ADMINISTRATIVE AMENDMENT

PROPOSED EXTERIOR REMODEL - SIGN AGE AND FACADE

T-2813 UPTOWN
 2120 LOUISIANA BOULEVARD
 ALBUQUERQUE, NM 87110

PROPOSED SIGN-AGE

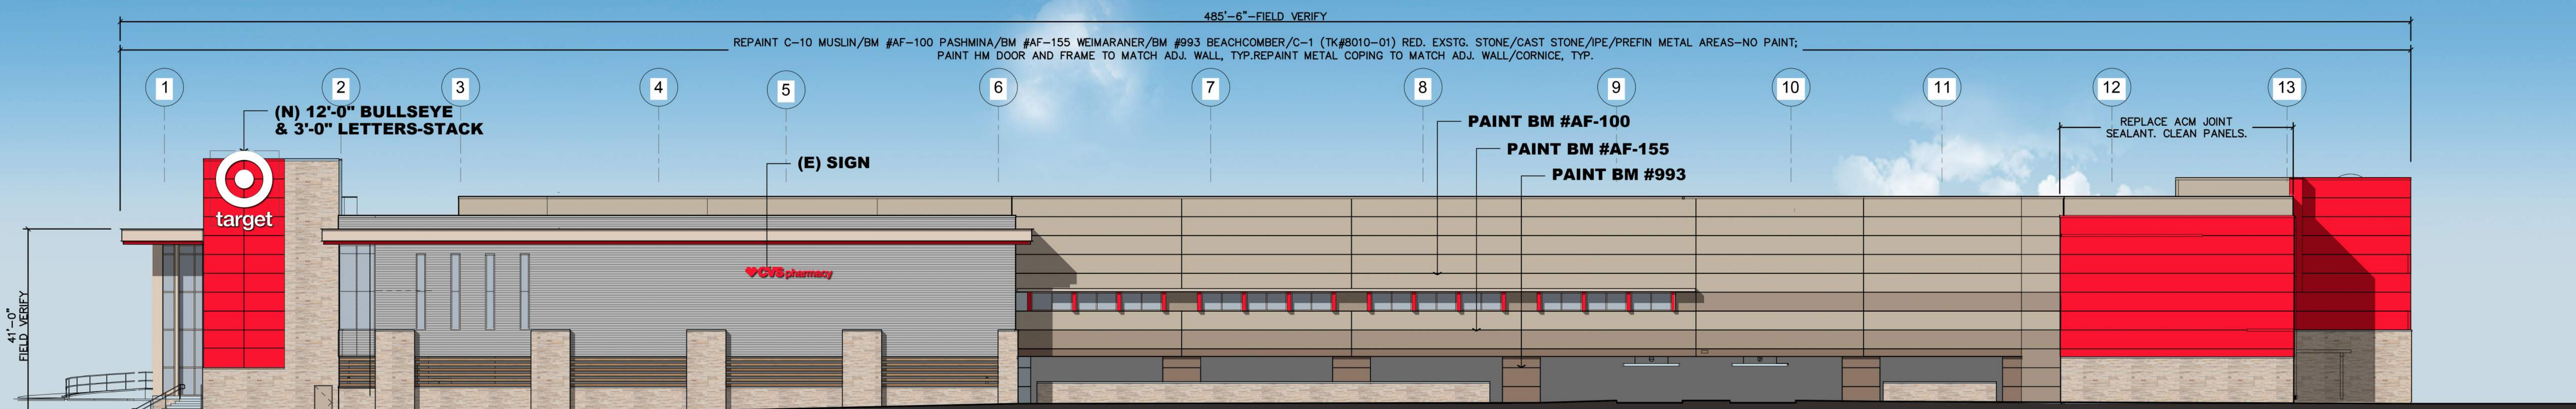
ALL SIGNS TO BE REPLACED/UPDATED, EXCEPT 'CVS PHARMACY' SIGN WHICH IS TO REMAIN. TWO (2) NEW SIGNS TO BE ADDED, ONE (1) ALONG SOUTH ELEVATION, ONE (1) ALONG WEST.

- A. WHITE BULLSEYE TO MATCH EXISTING SIZE AND LOCATION
- B. RED BULLSEYE TO MATCH EXISTING SIZE AND LOCATION
- C. WHITE BULLSEYE TO MATCH EXISTING SIZE AND LOCATION
- D. WHITE BULLSEYE TO MATCH EXISTING SIZE AND LOCATION
- E. WHITE BULLSEYE TO MATCH EXISTING SIZE AND LOCATION
- F. WHITE BULLSEYE (10') AND WHITE LETTER-STACK (2'6")
- G. WHITE BULLSEYE (12') & WHITE LETTER-STACK (3')

Proposed Elevations

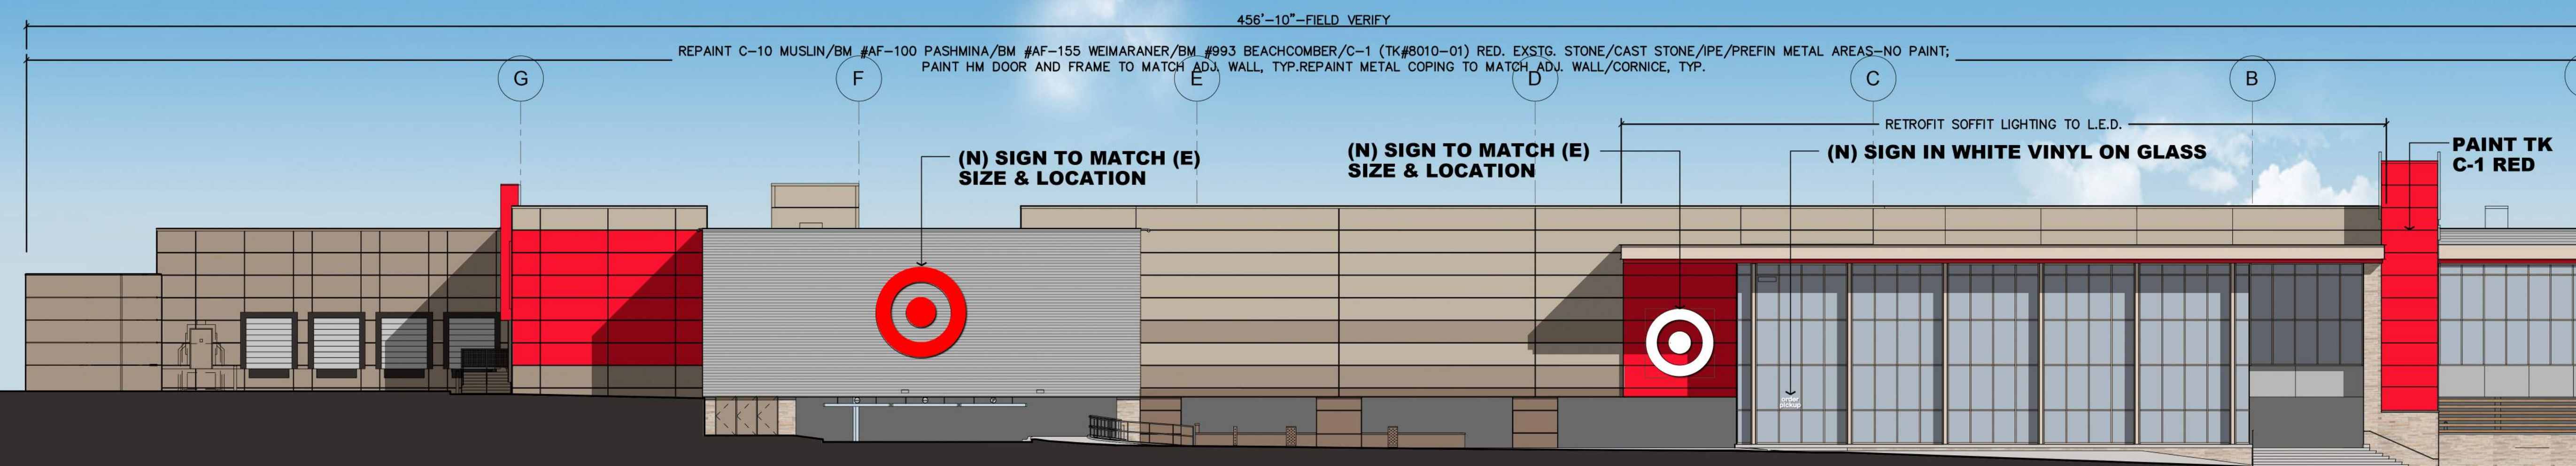
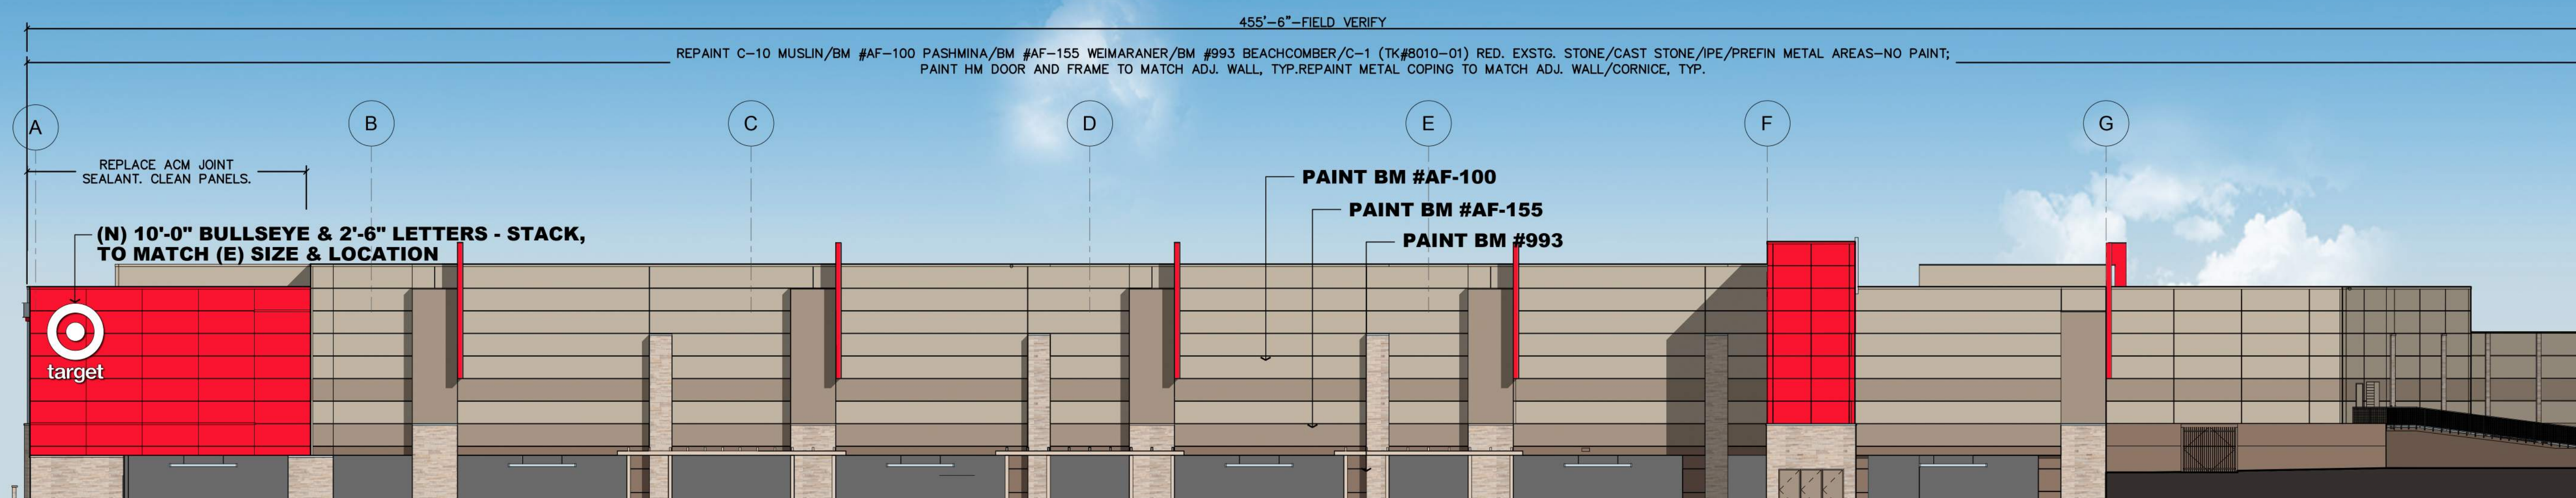
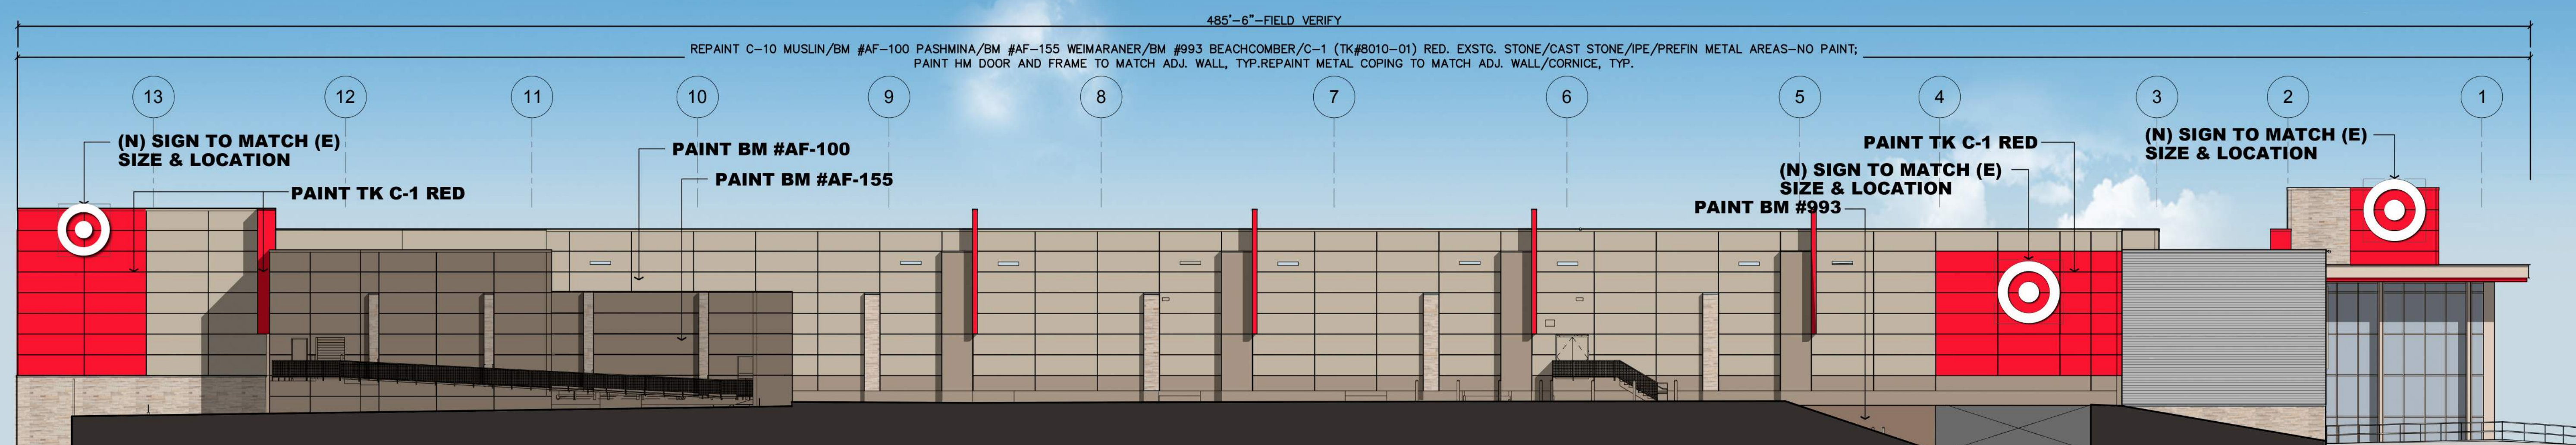
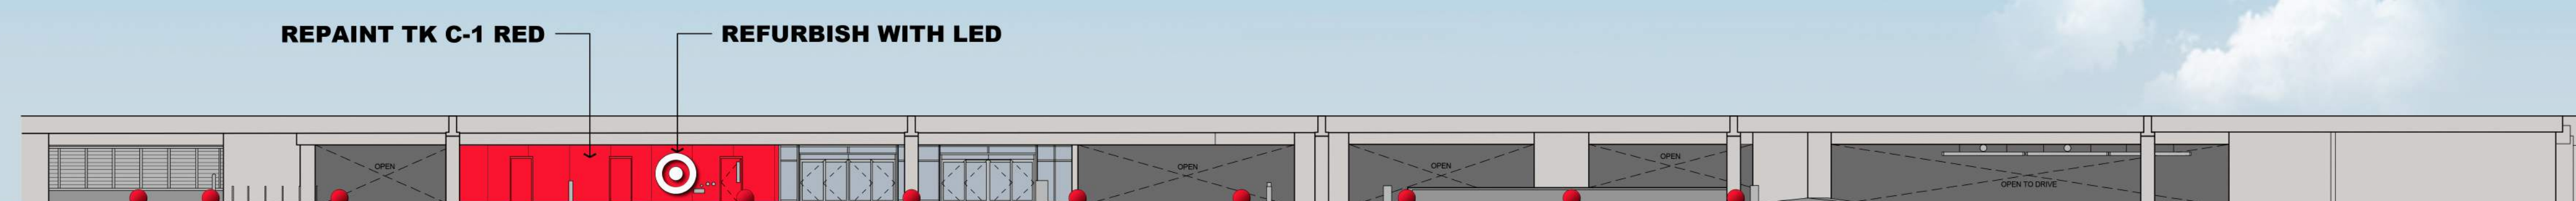
1. ALL PROPOSED FACADE COLOR CHANGES ARE WITHIN THE DESIGN SCHEME OF THE ORIGINAL SITE PLAN.
2. INTERIOR GARAGE TO BE REFURBISHED WITH EXISTING MATERIALS.
3. EXISTING SIGN SQUARE FOOTAGE TOTALS 762.9 SF, PROPOSED ADDS 331.6 SF.
4. MONUMENT SIGNS WILL BE UPDATED, COLORS TO INVERSE, NO STRUCTURAL CHANGES TO BE MADE.
5. ALL SIGNS TO REPLACE EXISTING, NO ADDITIONAL SIGNS TO BE ADDED.

- NOTE:**
- * ALL COLORS ARE FOR REFERENCE ONLY.
 - * EXISTING PREFINISHED METAL-NO PAINT, UNLESS NOTED OTHERWISE
 - * EXISTING STONE, CAST STONE, IPE & PREFIN METAL AREAS-NO PAINT; PAINT HM DOOR AND FRAME TO MATCH ADJ. WALL, TYP.
 - * RESEAL CAST STONE CAPS.
 - *STORE EXTERIOR WALLS ARE PRIMARILY PRECAST CONCRETE & STONE VENEER
 - *REPAINT BUS STOP C-1 RED-#TK8010-1
 - *BEN-2 : MODERN, COLOR.....SILVER
